The Sydney Gateway Team
John Holland Seymour White Joint Venture
10 Bourke Road
MASCOT NSW 2020

15th October 2021

RE: Sydney Gateway Place, Design and Landscape Plan

Figure 3:
Detail of the proposed balustrade with integral lighting.
(Source: JHSWJV / Conybeare Morrison International)

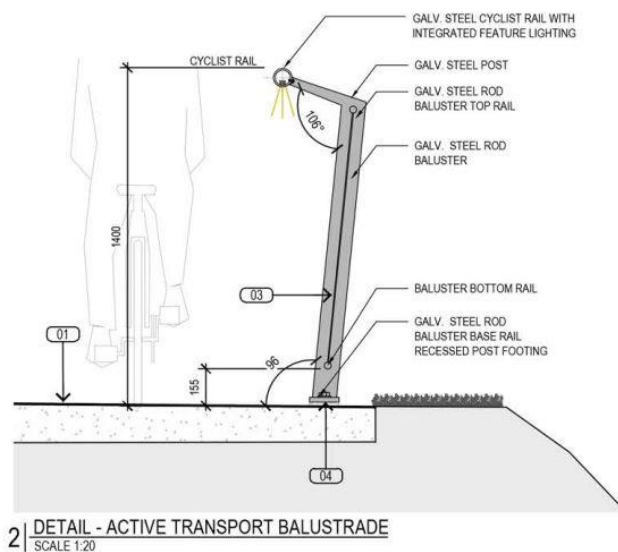
- The design for the handrails is very thoughtful (Figure 3) and reflects a deep engagement with stakeholders as the project developed.
- Good lighting along the entire length of the ATL is essential for safety and usability at night. The solution devised to install lighting in the handrails along the Alexandra Canal is excellent, removing the need for light poles, reducing visual clutter and providing smoother journeys. Feature lighting at the rest areas appears well-conceived.

Figure 4: Undefined sections of the ATL in the vicinity of the Domestic Terminals (Source: Source: JHSWJV / Conybeare Morrison International)

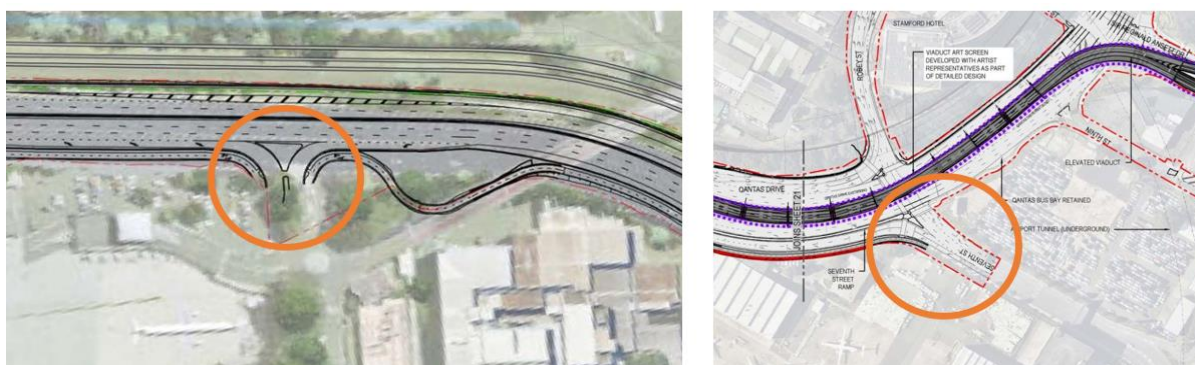
- There is no detail in the PDLP to show how the ATL connects with the Domestic Terminals or the Tempe Reserve. We are particularly concerned about the link to the Domestic Terminal and its end-of-trip facilities. The maps in Figure 4 highlight where significant gaps exist in the plans. To continue progressing the detailed design for the roads without keeping the ATL front and centre may lead to a compromised outcome for access to the terminal by both local residents, workers and travellers.

3. Provide detailed proposals for the connections of the ATL to Tempe and the Domestic Terminal as soon as possible

The construction of safe, comfortable, attractive and convenient links must be planned very carefully. We urge the project team to share proposals for each end of the ATL with relevant stakeholders early in the process to ensure that feedback can be taken on board and the best outcomes for local residents, commuters, travellers and airport staff achieved.

Figure 5: An map showing of the Sydney Gateway project and the ATL (in red) in relation to the existing cycle network. (Source: Google Maps / JHSWJV / Conybeare Morrison International)

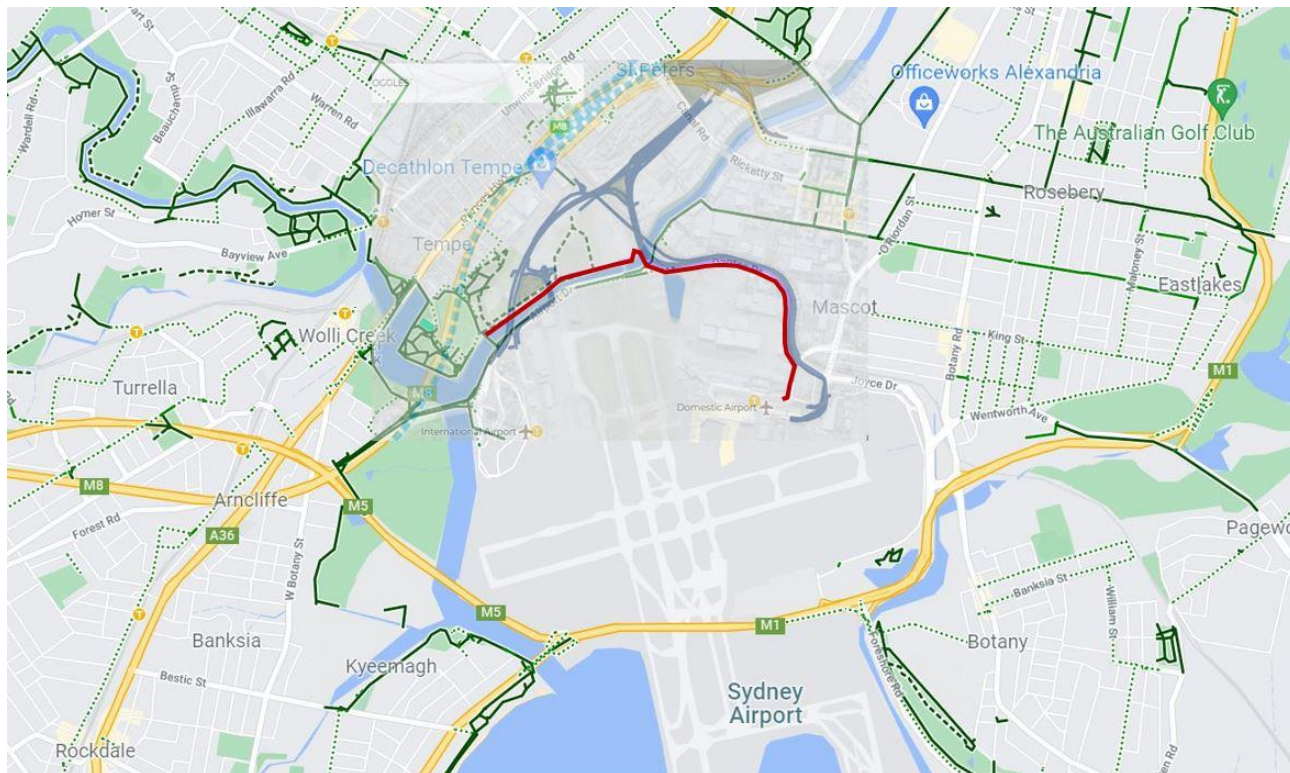
- The current plans do not allow for seamless connections to the wider cycling network. The ATL will not form a key part of the regional network without links to existing and planned cycle infrastructure. As can be seen in Figure 5, there are major missing links, particularly heading north-west towards Sydenham, north-east towards Sydney Park and south-east towards Randwick and its significant health and education precinct.

4. Ensure connections to the regional cycling network are accommodated in the design of the ATL

The project team is currently exploring opportunities (Figure 7) to connect the ATL with existing and future active transport infrastructure to ensure the ATL forms a central role in the regional network. Bicycle NSW supports this work and looks forward to continual stakeholder engagement to develop designs and shape the forthcoming Active Transport Network Strategy. It is essential that design and consultation work is not left too late so the ATL will include the critical junctions that allow linkages to the wider network.
